NOTICE OF PROPOSED CHANGE IN PROPERTY

Petition: x205

REQUEST ENCROACHMENT
 INTO WOODWARD, CONGRESS AND A
 PORTION OF THE NORTH/SOUTH PUBLIC ALLEY
 AT 600 WOODWARD AVE.

CITY OF DETROIT	
CITY ENGINEERING DEPARTMENT	
SURVEY BUREAU	
JOB NO.	01-01
DRWG. NO.	X 205

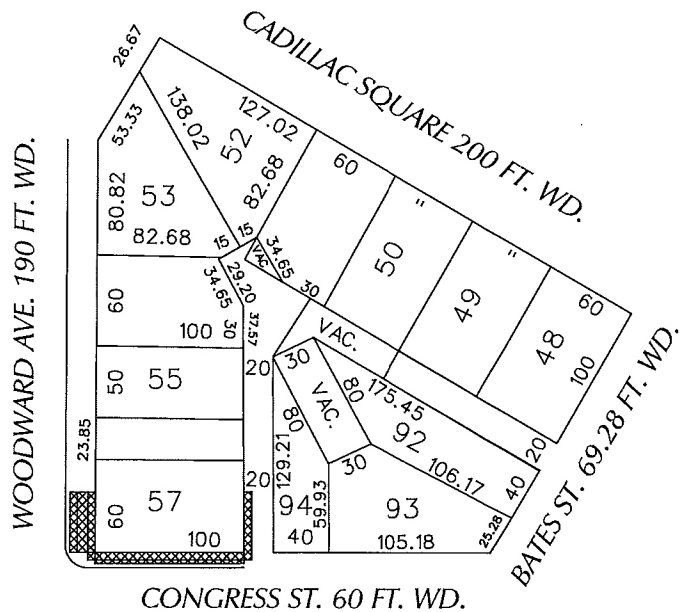
- Not Involved
- Involved; but asking you to hold action on this petition until further notice.
- Involved; but no objections to the property change.*
* See highlighted map for details pertaining to the elimination of below grade encroachment shown on DWG x205 per petitioner
- Involved; objection to the property change.
- Involved; but no objections to the property change...provided as easement of the full width of the public right-of-way (street, alley or other public place) is reserved.
- Involved; the nature of our services and the estimated costs of removing and/or rerouting such services are:

10/4/2018 - Per Michael Marks on behalf of petitioner, rear vault abandoned in place in 2014. Petitioner has agreed that this portion of underground encroachment no longer required. - C. Jones, DTE Energy
